Access Compliance Report

Public Rights-of-Way

Intersection ID: 46533	Main Street: GLEN_HOPE_LN	Cross Street: SUTTONVIEW_DR	Location:	N
ADA ID: 44E331126E44	Ramp Type: PerpDiag	Initial Pass/Fail: Fail	Overall Compliance: No	Severity Score: 10

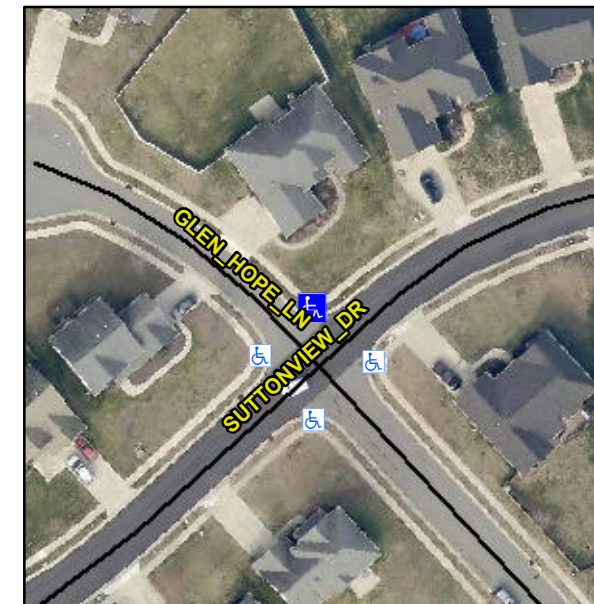
Not Found, R304.5.1, R304.5.3

Compliance	Description	Data	Compliance	Description	Data
N/A	Ramp Length (in)	48.5	Yes	Ramp Slope (%)	5.0
No	Ramp Width (in)	47.0	No	Ramp XSlope (%)	3.6
N/A	Flare Type LT	N/A	N/A	Flare Type RT	N/A
N/A	Flare Slope LT (%)	N/A	N/A	Flare Slope RT (%)	N/A
N/A	Flare Traversable LT?	N/A	N/A	Flare Traversable RT?	N/A
N/A	Landing Length (in)	N/A	N/A	DWS Provided?	N/A
N/A	Landing Width (in)	N/A	N/A	DWS Contrast?	N/A
N/A	Landing Slope (%)	N/A	N/A	DWS Length (in)	N/A
N/A	Landing X Slope (%)	N/A	N/A	DWS Full Width?	N/A
N/A	Landing Curb? (Y/N)	N/A	N/A	DWS Offset (in)	N/A
N/A	Shared Landing?	N/A			
N/A	Gutter Ponding?	N/A	N/A	Gutter Slope (%)	N/A
N/A	Gutter Lip Ht (in)	N/A	N/A	Gutter X Slope (%)	N/A
N/A	Painted X Walk1?	No	N/A	Painted X Walk2?	No
	X Walk 1 Direction	To SW		X Walk 2 Direction	To SE
N/A	X Walk 1 Width (in)	N/A	N/A	X Walk 2 Width (in)	N/A
	X Walk 1 Slope (%)	5.8		X Walk 2 Slope (%)	3.5
	X Walk 1 X Slope (%)	2.1		X Walk 2 X Slope (%)	7.1

Remove & Replace Curb Ramp With Two New Directional Ramps or Equivalent.
